**CITY OF TEMPE
DEVELOPMENT REVIEW COMMISSION**

Meeting Date: 05/23/2017
Agenda Item: 4

ACTION: Request for a General Plan Density Map Amendment, Zoning Map Amendment, Planned Area Development, Development Plan Review and Use Permit for Tandem Parking for a new mixed-use development in Transportation Overlay District (TOD), Station Area, for APACHE AND OAK, located at 1461 E Apache Boulevard. The applicant is arTHAUS Projects.

PLANT LEGEND

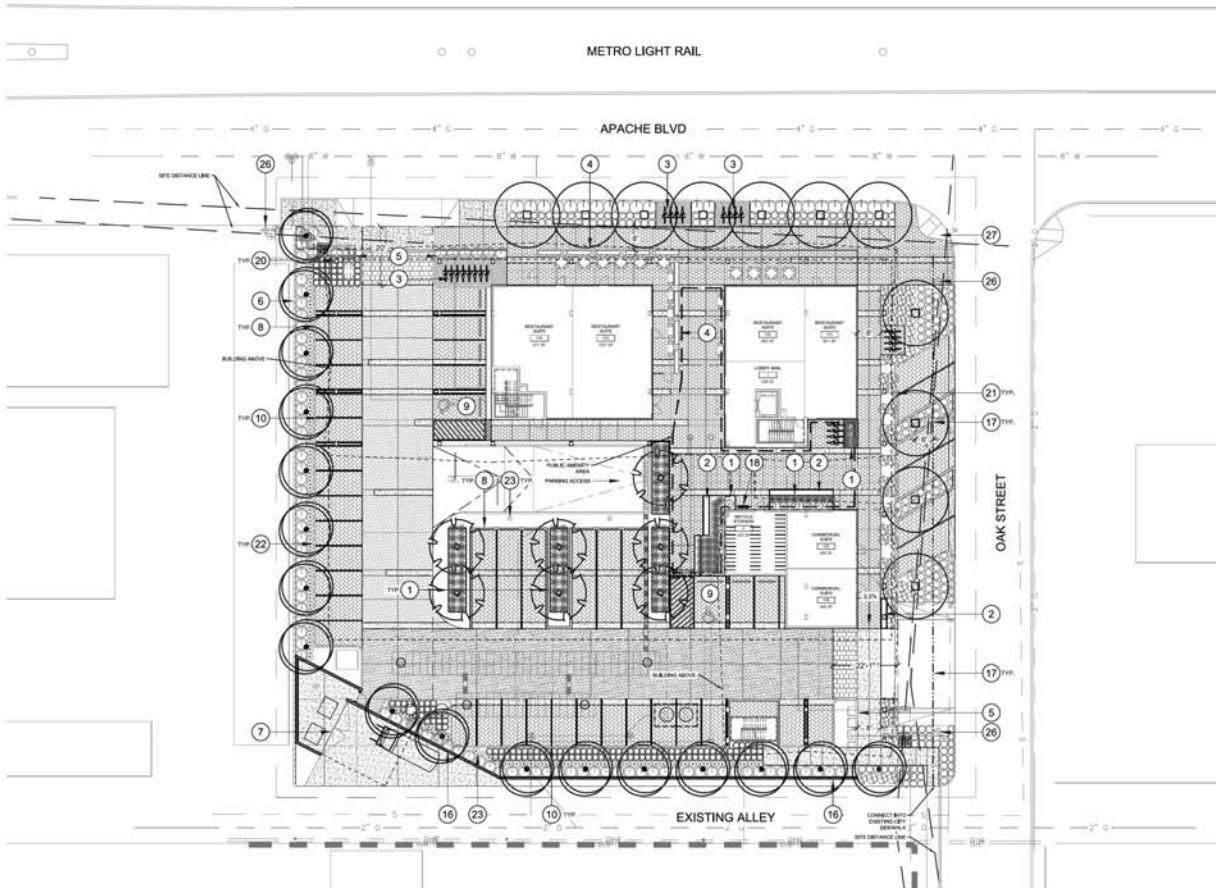
The proposed palette is low-water use with simple massing of plants. The Apache and Oak street fronts use single trunked Chinese Pistache, which produce a dense canopy of shade in the summer, fall color change, and dormant branches conducive to decorative lighting. The Apache front ground cover includes Purple Trailing Lantana and Yellow Dot low growing vegetation to maximize visibility to the site. Taller Ruellia are used in massing behind the Yellow Dot along the Oak street front. The Arizona Ash is used along the western side, providing summer shade and a brief dormant period for winter sun. The western side is a depressed retention area with vehicles overhanging the planting area filled with Tuscan Blue Rosemary, a taller growing variety (not prostrate) and Salvia greggii, a pink flowering herbaceous plant. The southern landscape buffer is proposed for one of three tree species, either Arizona Ash, Chinese Pistache or Evergreen Elm, the selection to be coordinated with the property owners to the south of the site who would face this landscape buffer.

NOTE:
FINAL SOUTHERN PROPERTY SCREEN TREE DETERMINATION WILL BE
GENERATED BY COMMUNITY INPUT BASED UPON THE FOLLOWING OPTIONS:
FRAXINUS VELLUTINA (PREFERRED)
DALBERGIA SISSOO
ULMUS PARVIFOLIA

Sissoo Tree height at years 3, 5, and 10

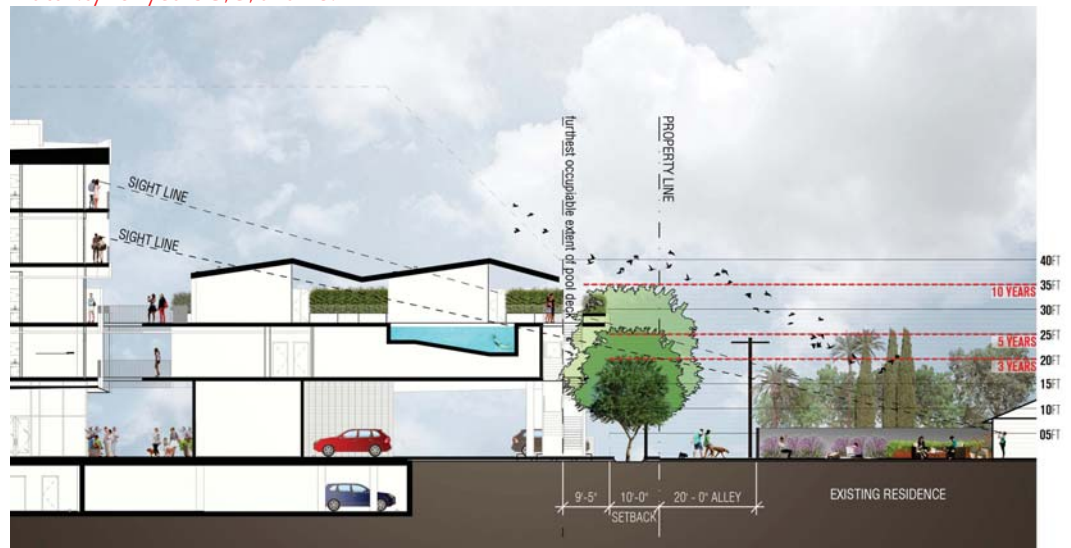
5. Too intrusive. There is only 30 ft. of space between our back-yard fences and the start of his 30 ft high back of his building. Then on top of that he wants to add a pool/amenity area with 2 rooms that would actually be 41 ft high. Anyone up there could easily see into the back yards of the neighborhood. Trees will not grow that high that fast. The design fits the city's limits by slanting the top roof and pulling it back 10 ft. In comparison, both Gracie's and NEXA buildings are 80 ft away from back yard fences. Site lines on both those properties are blocked.

DEVELOPER RESPONSE: As noted in our response to items 1 and 4 above, the proposed development is 110' away from the South property line, considering the alley width and backyard setbacks of the neighboring properties the distance is increased to approximately 170'. We have agreed to modify the proposed tree species (Heritage Oak) and propose to plant one of three faster growing varieties (Chinese Elm, Sissoo, or Arizona Ash) and would allow the neighbors to the South to determine which of those three (3) City of Tempe approved options is most desirable. Reference the below section illustrating the tree buffer at height maturity for years 3, 5, and 10.
